U.S. NUCLEAR REGULATORY COMMISSION

Report No. 50-263/82-05(DEPOS)

Facility Name: Monticello Nuclear Generating Plant

Inspection Summary

Figure 1
 MONTICELLO NUCLEAR GENERATING PLANT
 Functional Organization for Onsite
 Operating Group

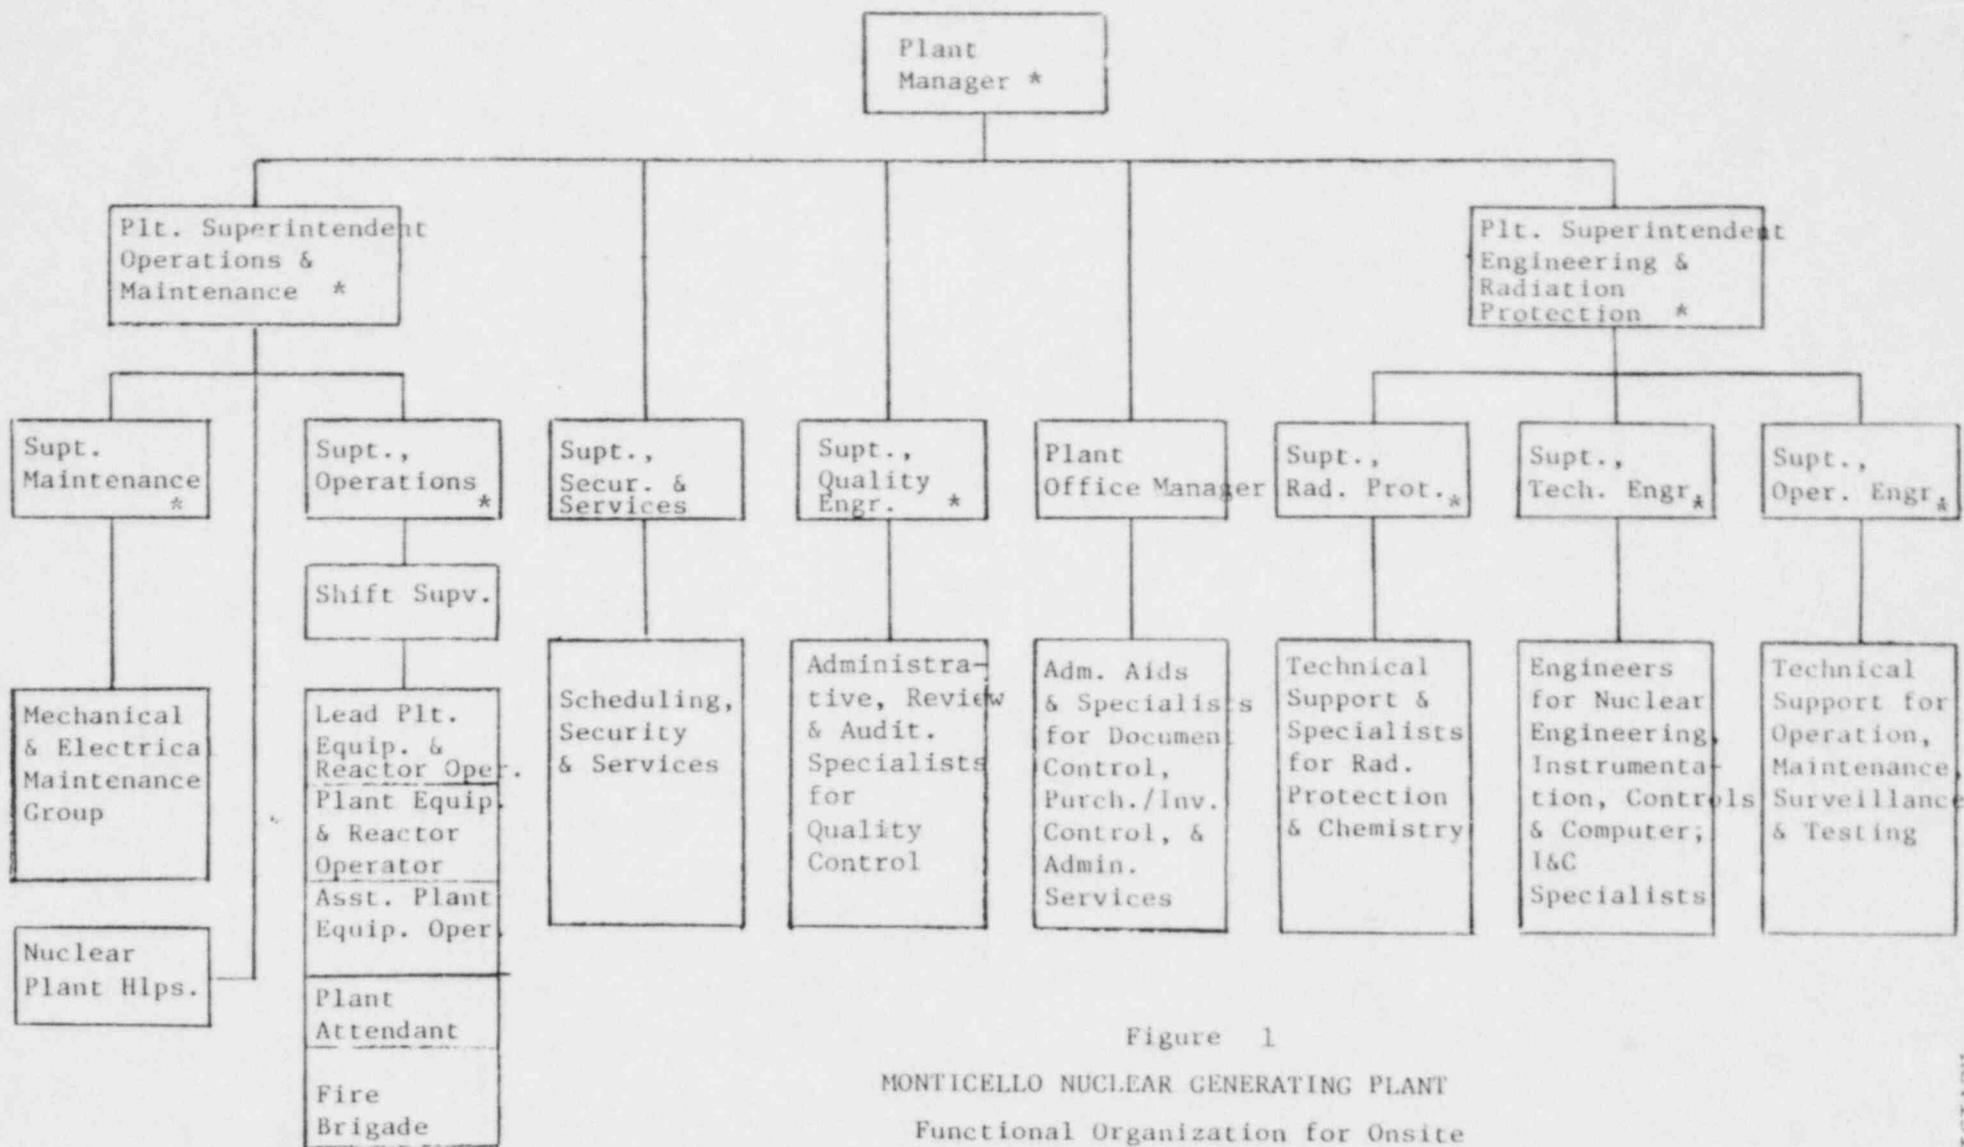
The emergency onsite organization is described in Section 5.0 of the Plan which includes both a functional and an onsite emergency organization chart. These two charts are attached to this report as Figure 1 and Figure 2. The position descriptions and the organization are adequate from both a management and a functional standpoint.
